SAFETY BULLETIN

Ref Document No.	SB19001	Issue No.	1
Subject	RAMBOR® Longwall Face Drill Leg Clamp		
Release Date	28-06-2019

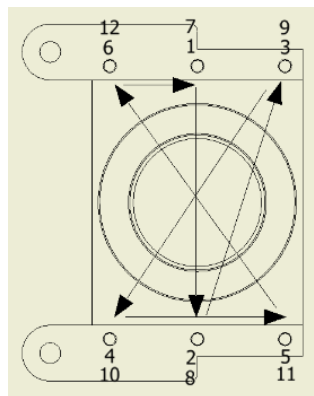
A contributing factor that could cause the leg clamps to lose grip on the LFD leg is that the M8 x 35 Socket Head Cap Screws which are used to tighten the leg clamps are not tightened adequately.

It also needs to be checked that these bolts are of grade 12.9

PPK has conducted testing to confirm that the clamp arrangement provides sufficient grip when the clamp screws are of correct grade and tightened to the recommended torque of 45Nm. It was found that more than 4000kg-f was required to start pushing the longwall drill leg out of the clamp. The maximum thrust provided by the longwall drill is approximately 1134kg-f. Rubber inserts in the clamp prevented the longwall drill leg from moving at a high velocity.

1. The 0280-0002 clamp is secured using the recommended six M8 x 35 grade 12.9 bolts tightened to the recommended torque of 45Nm.
2. Clamp retaining bolts are secured using Nyloc nuts.
3. Clamp retaining bolts are tightened to the recommended torque using the tightening sequence below:
